**UNITED STATES ENVIRONMENTAL PROTECTION AGENCY**  
**REGION IX**  
**75 Hawthorne Street**  
**San Francisco, CA 94105-3901**

October 28, 2020

Re: Technical Evaluation Comments and Information Request #4 for  
CES-Mendota Site Underground Injection Control (UIC) Permit Application  
Class VI Pre-Construction Permit Application No. R9UIC-CA6-FY20-1

## Evaluation of Proposed Testing and Monitoring Activities at the CES-Mendota Class VI Project

Location of monitoring wells

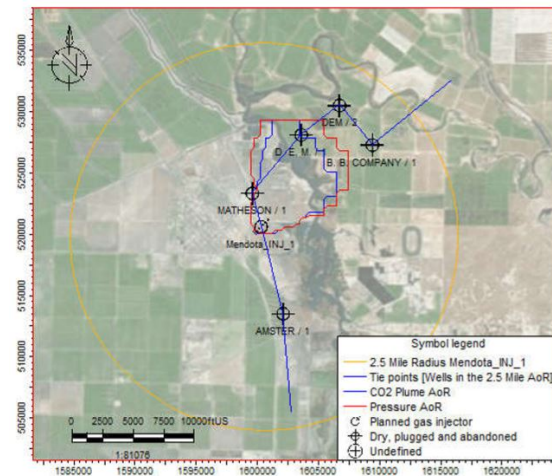
The map of monitoring well locations can be compared to the expected extent of the plume after 20 years, as shown on the map to the right of the figure above (from Figure 12 of Attachment B). While the scales of the maps in the plans are different, they have the same legend and it appears that the monitoring wells will be located within the defined AoR and in the anticipated direction of plume and pressure front movement. The suitability of these proposed locations will be refined as the AoR modeling evaluation proceeds.

- Please provide a map that shows the location of the monitoring wells at a scale that also shows the extent of the plume and pressure front (i.e., Figure 12 of Attachment B and Figure 1 of Attachment C at the same scale).*

*Figure 14: BB Co. 1 wellbore after P&A operation*

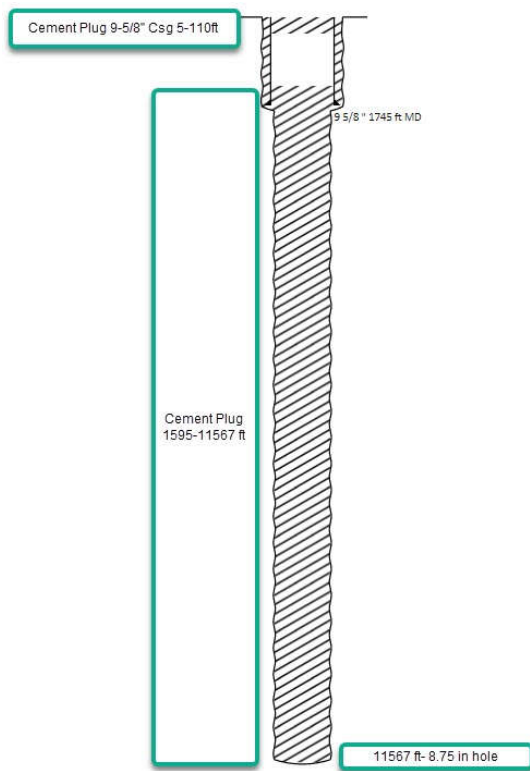
The Amstar 1 and BB Co 1 wells currently have only one relatively shallow casing installed (the Amstar 1 has a cemented surface casing at 1,020 feet and the BB Co 1 has a cemented surface casing at 1,745 feet). Each well was drilled much deeper but no production casing was installed and instead each was open-hole plugged and abandoned, meaning just a small plug of cement is present inside each well's drilled production hole. CES proposes to re-enter these two wells, drill out these plugs, and re-plug them. Under the CES proposed plan, the two wellbores would be filled with Class G cement from total depth upward into the surface casing and from 110 to 5 feet inside the surface casing. It is unclear why CES is proposing the use of Class G cement, instead of a CO<sub>2</sub> corrosion-resistant cement. The depth to the base of USDWs in each well is not provided.

- *The deepest USDW (calculated at ~1,609 feet bgs) is 5,700 feet above the Moreno Shale which is the secondary confining zone, as stated in the application. Please provide the depth to the base of USDWs in each of the two wells to be re-plugged and abandoned for corrective action.*

- *Please clarify whether CES proposes to re-plug and abandon the BB Co 1 well prior to commencement of injection activities.*
- *The plugging procedures for Amstar 1 and BB Co 1 on pages 25 and 26 reference a casing diameter of 9 5/8 inches; however, figures 14 and 15 show that the hole is 8.75 inches. Please clarify the discrepancy.*
